**TOWN OF HERNDON, VIRGINIA
ARCHITECTURAL REVIEW BOARD
WORK SESSION AGENDA
JUNE 3, 2020
HERNDON COUNCIL CHAMBERS BUILDING
765 LYNN STREET
7:30 P.M.**

Case Number & Type: ARB #20-014; Wall Sign(s)
Case Summary: Install two (2) new wall sign on the parapet of an existing commercial office building.
Case Location: 12900 Worldgate Drive

Subject: Discussion Item – Park Place Zoning Map Amendment Design Review

PARK PLACE
ZONING MAP
AMENDMENT
TOWN OF HERNDON, VA

SIGN ELEVATION $3/8" = 1'-0"$

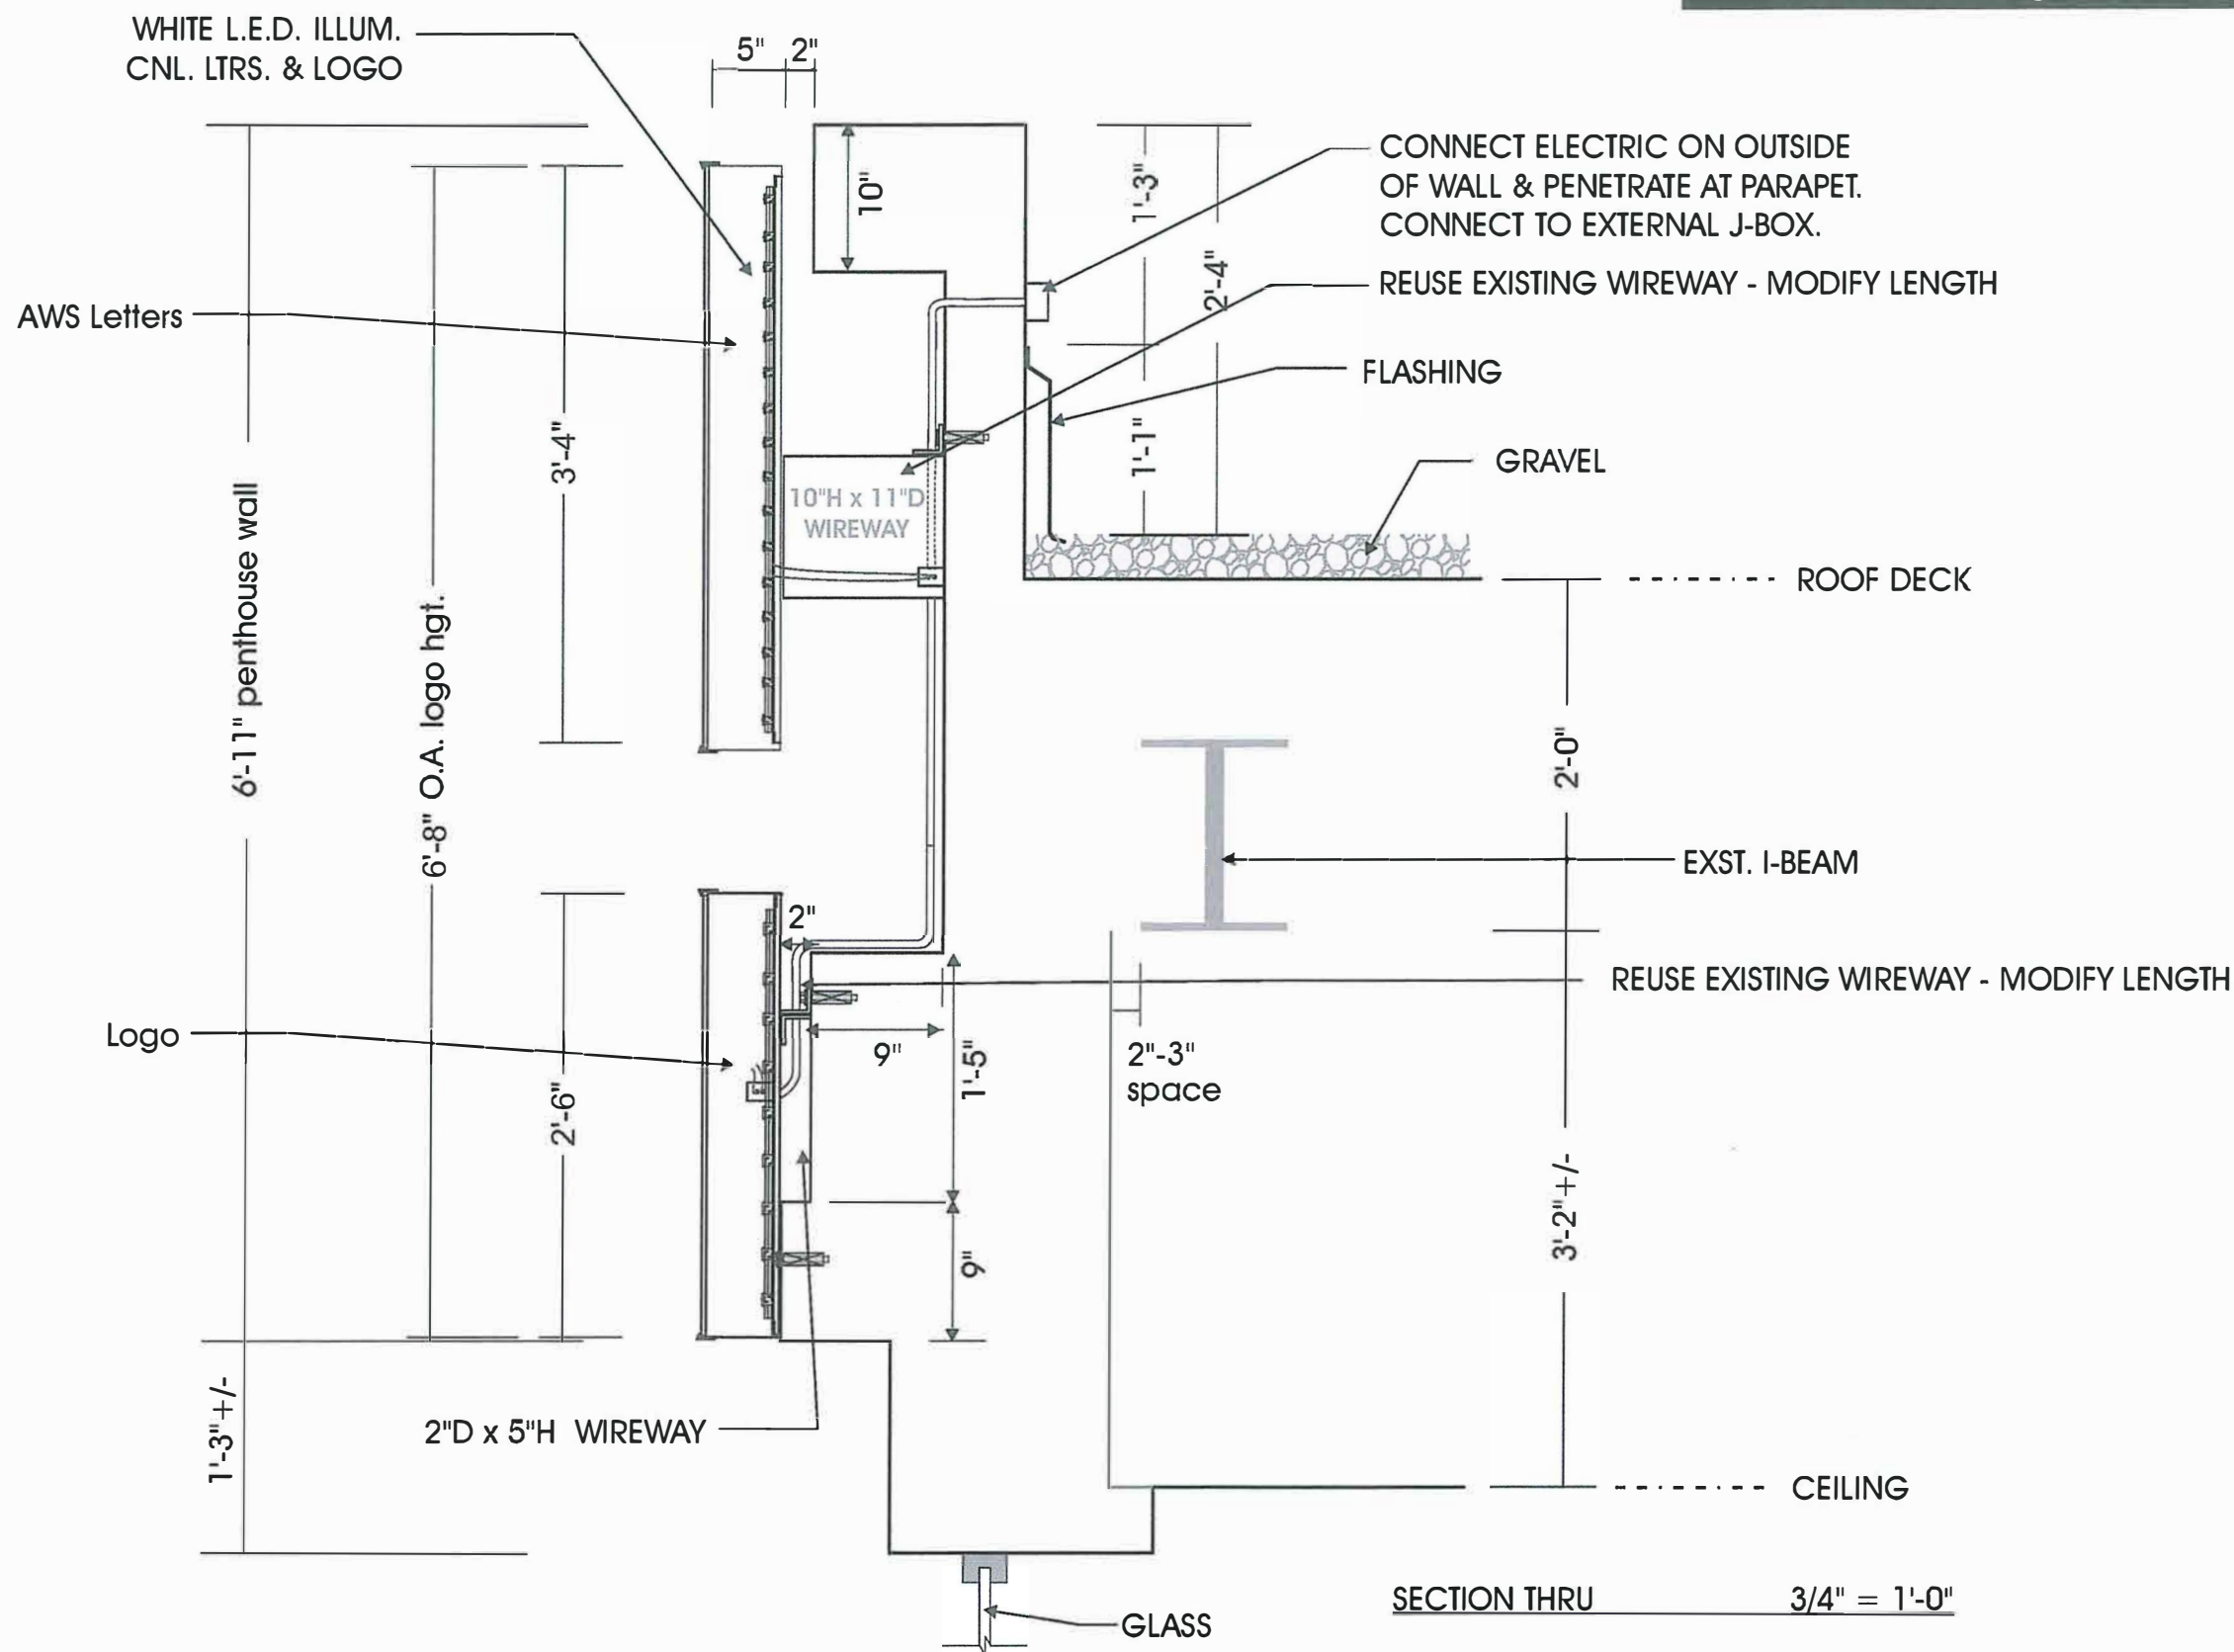
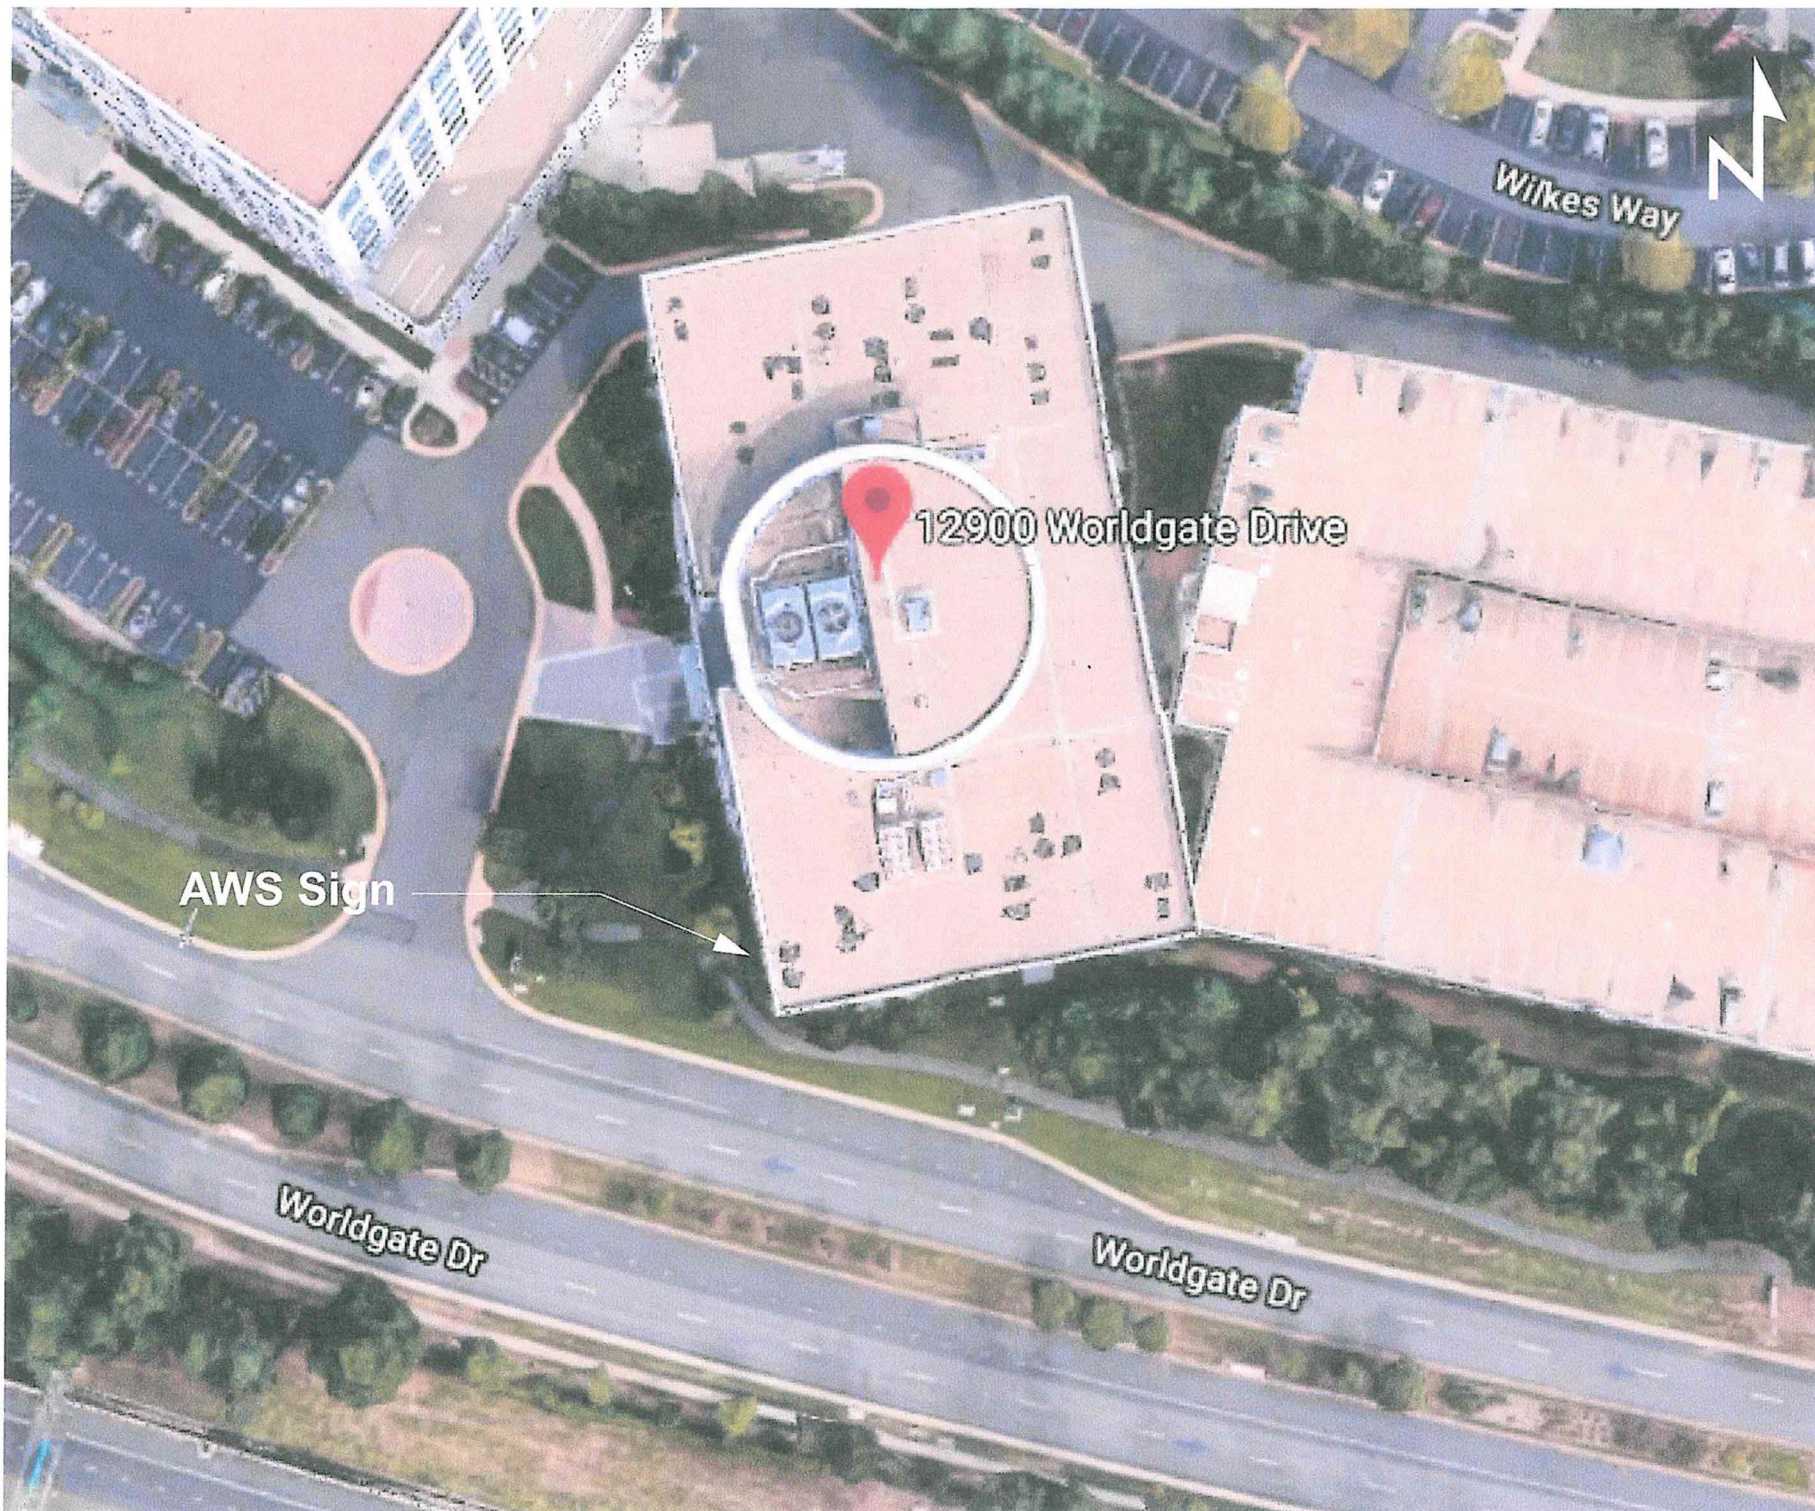
1. The application proposes 75.6 square feet of signage to be placed on a parapet along two elevations that face Dulles Toll Road and Worldgate Drive. Section 78-141.5. - Sign standards for properties in the Worldgate District (PD-W), Table 141.5(c) specifies that two parapet signs per building are permitted with a maximum sign area 150 square feet per sign are authorized in the PD-W zoning district. Thus, the proposed signage meets the location, size, and number standards of the referenced zoning

ordinance section. The subject building at this address does not have any existing parapet wall signs, though the exposed electrical raceways have remained after removal of previous signs or remained unused over time. Should this case be approved by the Board and the proposed signs installed, the subject building will not be permitted to have additional parapet signs installed in the future, in accordance with the referenced zoning ordinance section.

2. The proposed signs meet the Town Zoning Ordinance, Section, 78-140.6. - *General standards for all signs* regarding, the sign types, design, placement, and illumination. It should be noted that though exposed electrical raceways are no longer permitted in Section 78-140.4 - *Prohibited Signs* of the Town's Zoning Ordinance, the existence of the original raceways is a nonconformity that was likely a permitted sign feature when the building was built. So long as the existing exposed electrical raceways are not expanded, enlarged, replaced or otherwise removed, the raceways may be reused for the purpose of installing these new signs.

3. The proposed signs generally comply with the applicable design criteria within the Town's Architectural Control District as specified in Section 58-96 of the Town Code of Ordinances (Attachment #4). Staff finds that the proposed parapet wall signs will be consistent with previous sign approvals for the commercial office complex and will not detract from the architecture of the building or that of the adjacent buildings. Thus, staff believes that the proposed signs will comply with the review criteria specified in the Town Code of Ordinances.

Motion Alternatives:	1. Motion to deny the application. 2. Motion to approve the application as submitted. 3. Motion to approve with condition(s). 4. Motion to continue public hearing to a date certain or the next ARB Public Hearing for action to address a specified design issue or concern of the Board.
Recommended Motion:	Motion for approval of ARB #20-014, in accordance with Alternative #3, with the following conditions: 1. The proposed signs shall not expand, enlarge, replace or otherwise remove the existing electrical raceways proposed for use for the new parapet wall signs; and 2. The proposed sign shall be installed in substantial conformance with the original application design and construction details as submitted on or about April 2, 2020.
